Docket No. 50-271
BVY 03-115

Vermont Yankee Nuclear Power Station

Technical Specification Proposed Change No. 257

Calculation VYC-0693A – APRM Neutron Monitoring Trip Loops

FIGURE 2.1-1

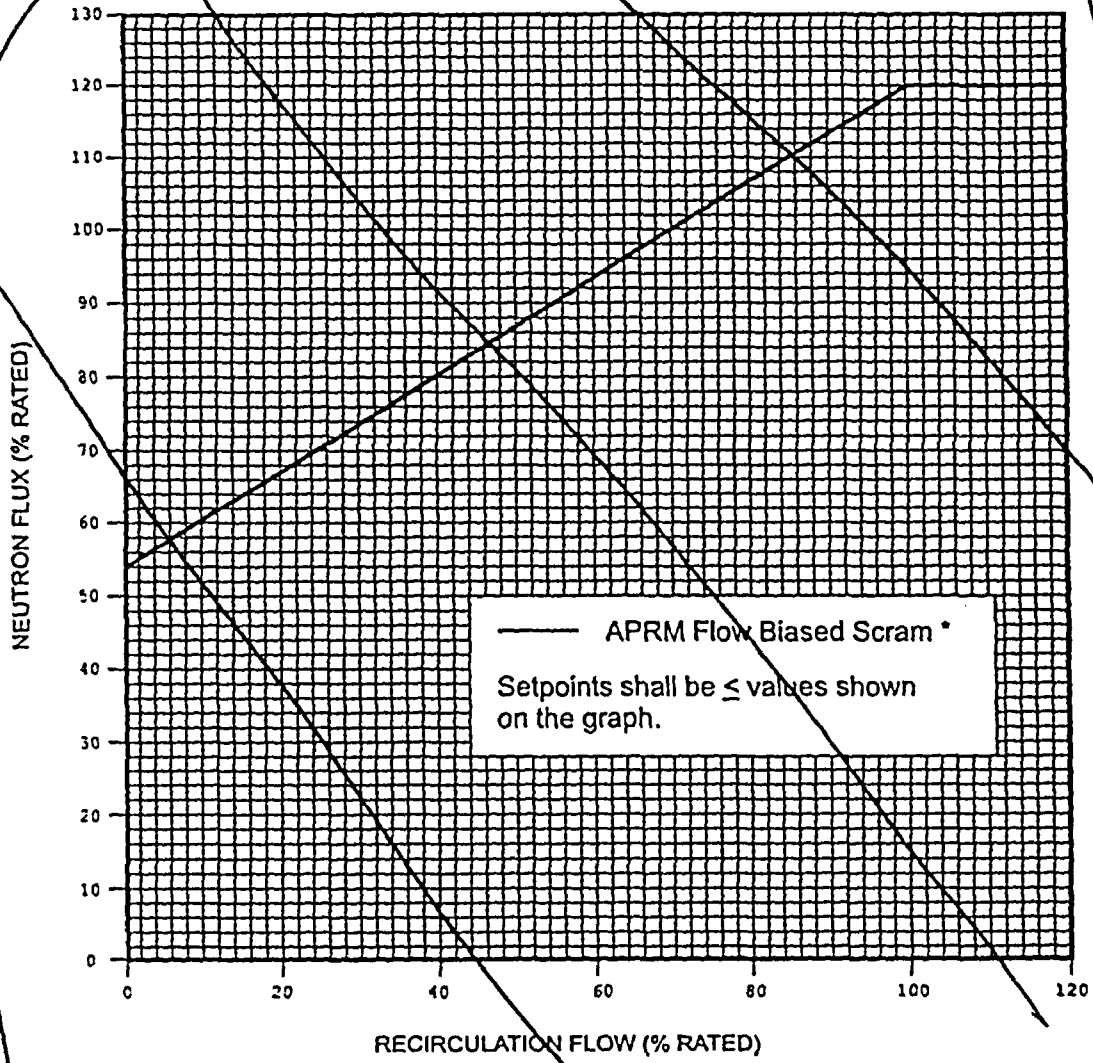
TS Figure 2.1.1 (current page 11)

TS Figure 2.1.1 does not provide any requirement not included in the stated algorithms for this function. Because the figure is redundant, it can be eliminated from TS without any change in technical requirements. In addition, elimination of this figure is consistent with Standard Technical Specifications.
